AD HOC COMMITTEE REQUESTS

Randford
CARPENTER GATE

SCNC - AD HOC COMMITTEE REQUESTS

VENTURA BLVD EDGE - LAYERED HEIGHT

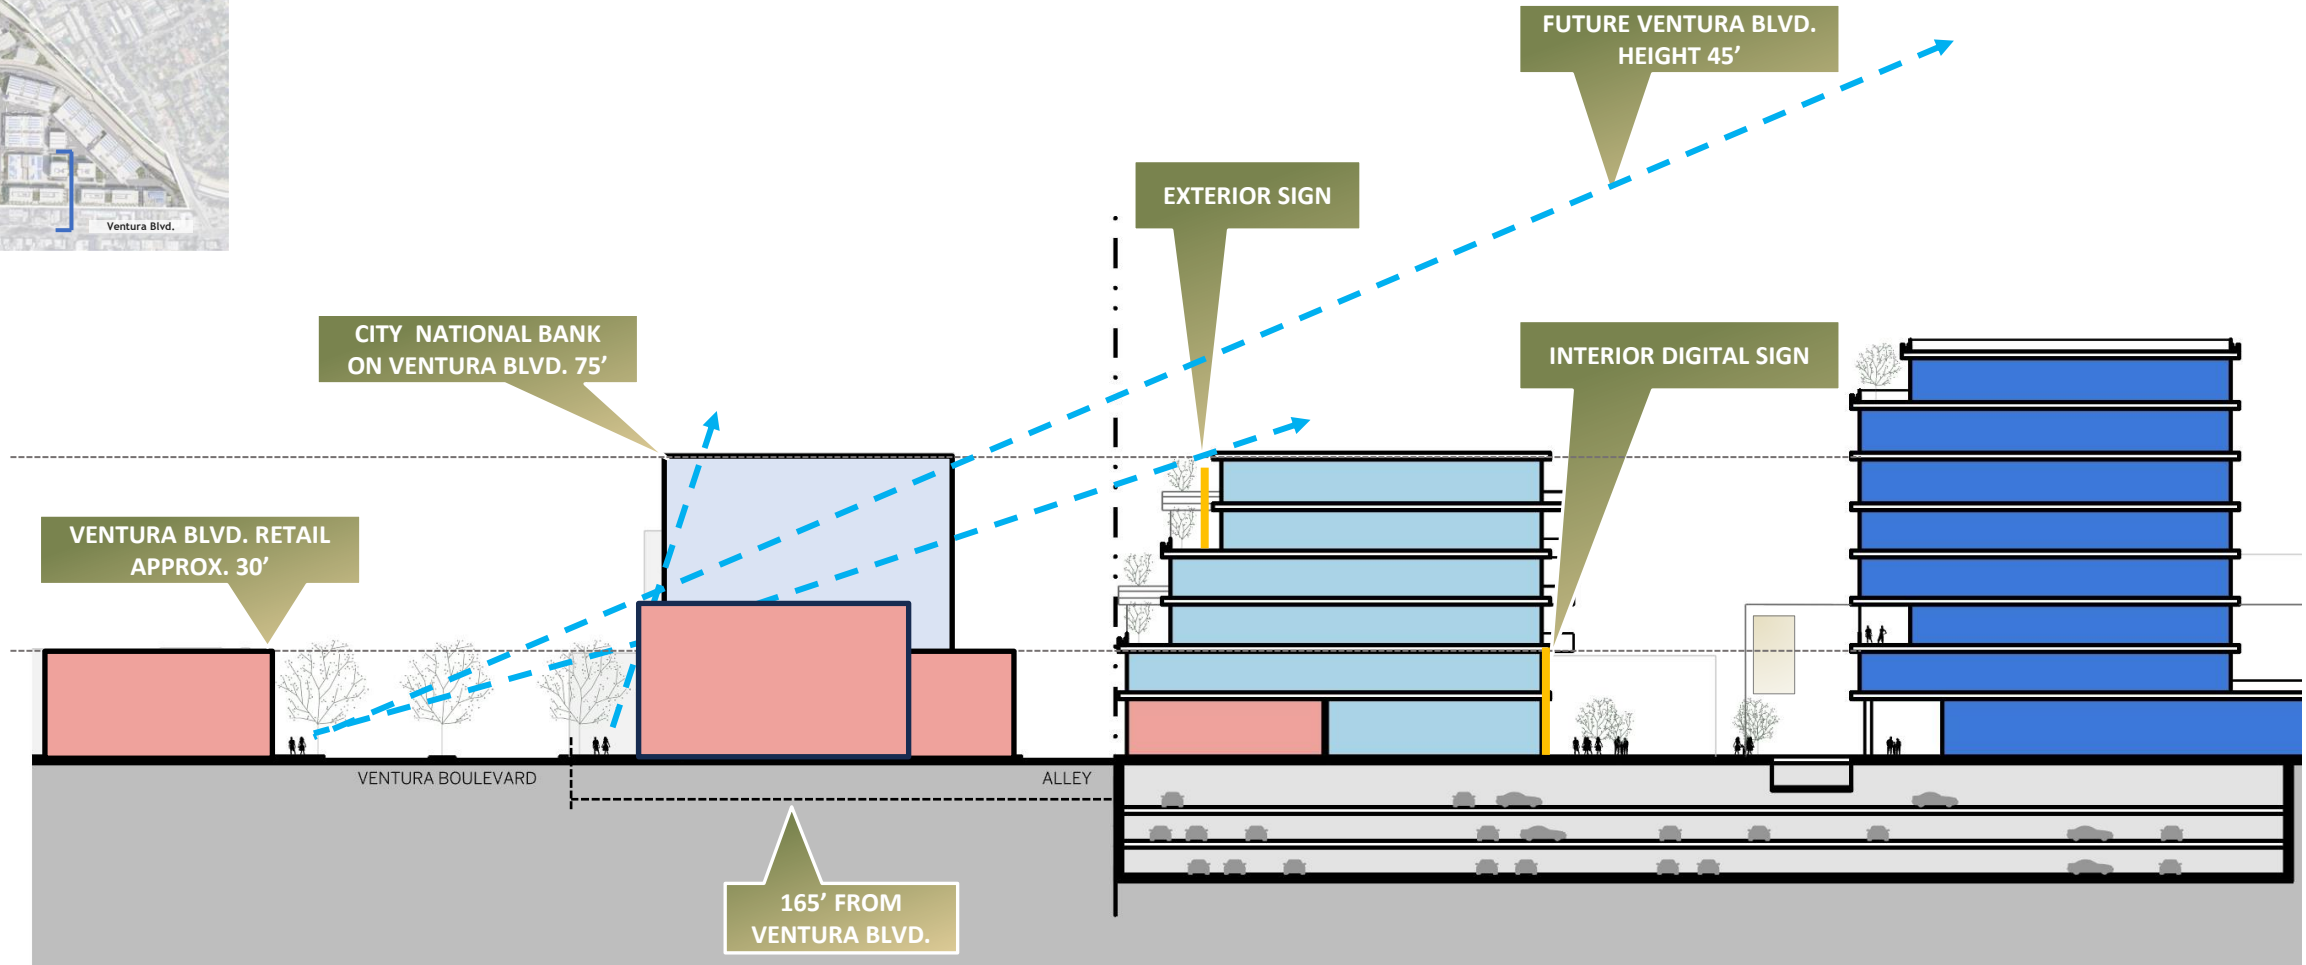
04: Zone [Q] M2-1-RIO (70-foot height limit) in the "south of the Los Angeles River section of the property" remains within 100 feet of the entire perimeter of the Radford Studio Center property, with step backs on the Ventura Alley adequate to preserve the sight lines of pedestrians on Ventura Boulevard. (Step backs to accommodate large potted plants.)

- The South Lot's existing [Q]M2-1-RIO zone currently has no height limitation
- The Project would impose maximum height limits throughout the entire site

- Buildings along the perimeter of the South Lot would be located away from public rights-of-way
- Buildings along the southern perimeter would be located approximately 150 feet away from the public sidewalk along Ventura Boulevard, separated by an alley and commercial buildings

- Buildings along Radford Avenue would be set back by 10 feet
- Buildings along Colfax Avenue would be set back by 15 feet
- Buildings along the eastern perimeter would be separated by the approximately 150-foot river channel

- As shown in the Initial Development Plans, the sight lines of pedestrians on Ventura Boulevard are preserved.
- The Project is designed to concentrate height and massing of buildings away from site edges and incorporate the highest quality design elements to ensure compatibility with the surrounding areas, while also achieving the spatial, technological and operational needs of a modern studio campus.

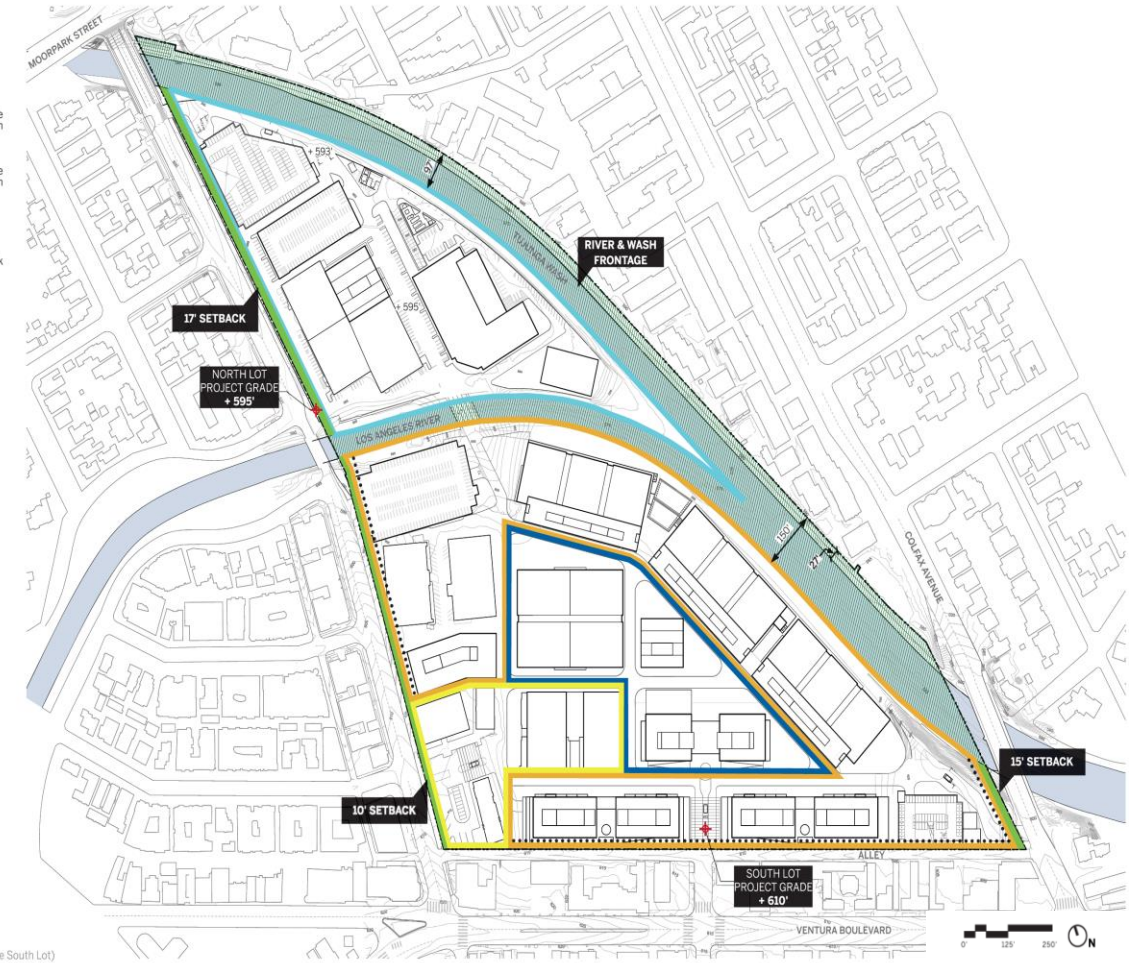
05: The inner property not within the first 100 feet of the "south of the Los Angeles River section of the property" perimeter can be up to 90 feet in height.

- The South Lot currently has no height limitation
- The Project would impose maximum height limits throughout the entire site
- Subarea C, which is located in the central portion of the South Lot hundreds of feet away from all site edges, would be subject to a base height limit of 75 feet, and would allow up to 60 feet of additional height in up to 30% of Subarea C.
- As shown in the Initial Development Plans, there is only one building that is greater than 75 feet in Subarea C, which is 120 feet in height.

VEHICULAR SITE ACCESS

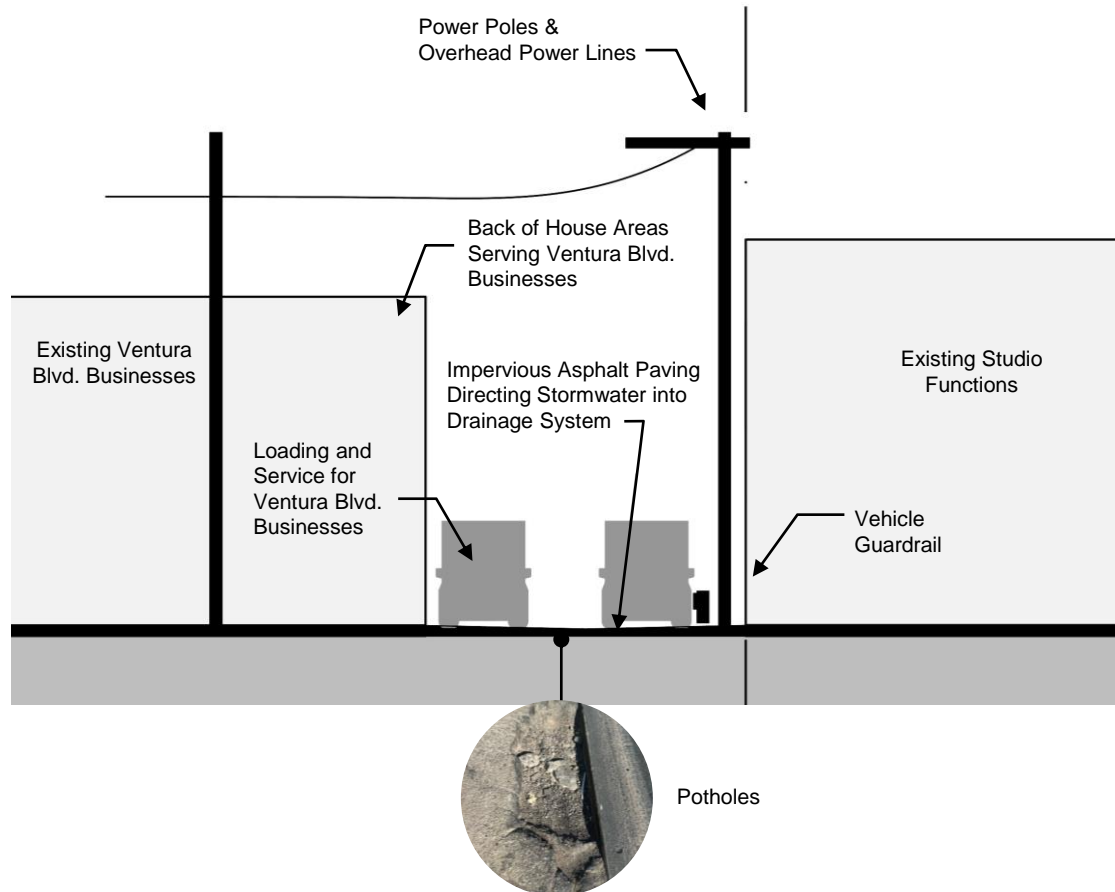
11: No trash pick-up or deliveries from the Radford Studio Center through any portals along the Alley from Colfax to Radford. No in and out period along the alley from the Radford Studio Center, except from the proposed new Carpenter Gate.

- The public alley is designed as a service corridor for all of the adjoining businesses without any limitation and the Project does not propose any changes.
- If the public alley capacity was artificially increased, it would promote more cut-through traffic and negatively impact the adjoining businesses.
- Draft EIR analyzes a LID BMP Alley, which may incorporate stormwater best management practices that would filter, clean, and/or retain stormwater runoff from nearby impervious surfaces.

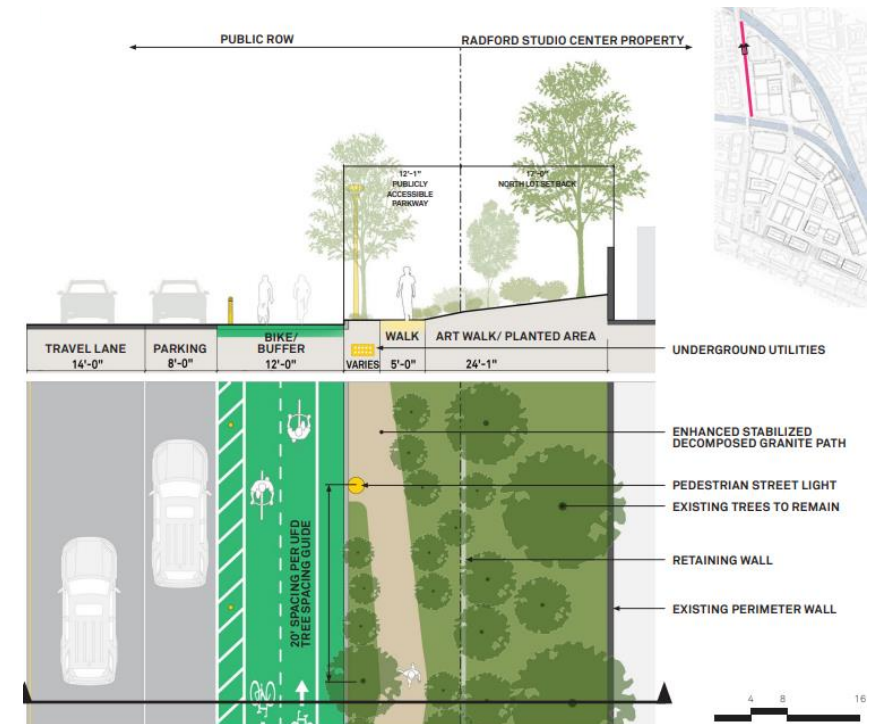
13: Create a publicly accessible walkable landscaped parkway adjacent to the proposed bikeway that features parklike cut-outs and offers space for public art installations along Radford Avenue from the Los Angeles River to the Tujunga Wash. This will help mitigate the impervious/surfaces/heat island effects of the facility. As a public parkway, Radford Studio Center would be responsible for maintenance.

- Streetscape improvements along Radford Avenue are configured into two primary spatial zones:
 - a 24-foot planted zone, in which elements such as trees and site furnishings are located, and
 - a 5-foot pedestrian clear zone, which allows for unobstructed pedestrian circulation free of obstacles. These two zones run parallel to the curb and street.
- Improvements include a protected two-way bike path, and enhancements to the existing Radford Art walk with pedestrian lighting, upgraded vegetation, and a refresh of the existing decomposed granite path.

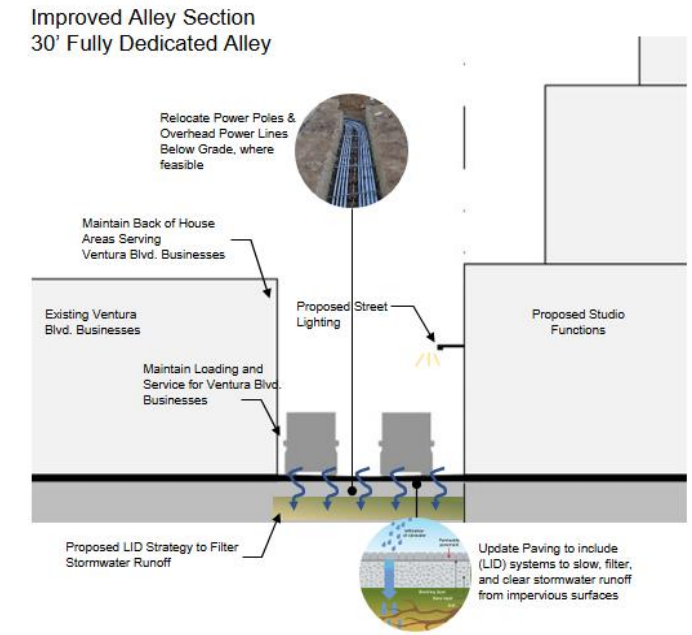
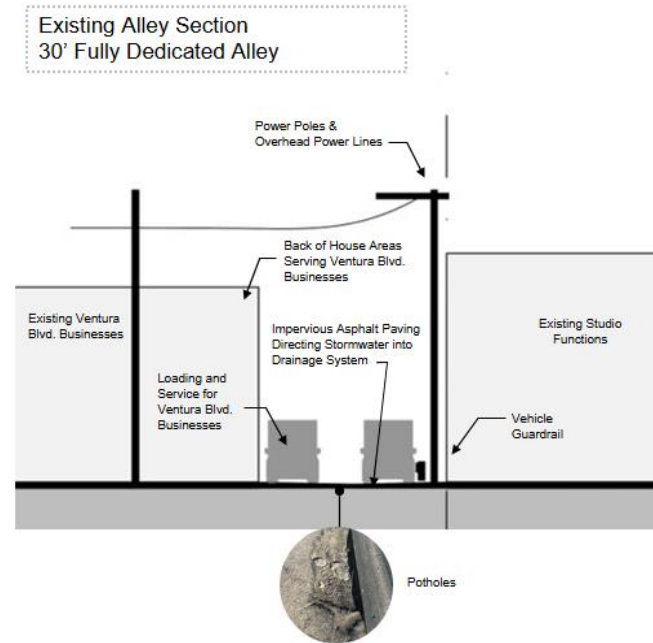
37: Alley public utility poles to be buried, or at the very least, moved from the north side of the alley to the south side of the alley since the utilities only feed the south side of the alley.

- The Draft EIR analyzes potential improvements to the alley, including undergrounding of utilities.
- The Project team has engaged LADWP to confirm initial feasibility.
- LADWP will begin to further detail out feasibility and plans. This process will require the engagement of all applicable agencies, the Ventura businesses, and their respective property owners before any work can commence.
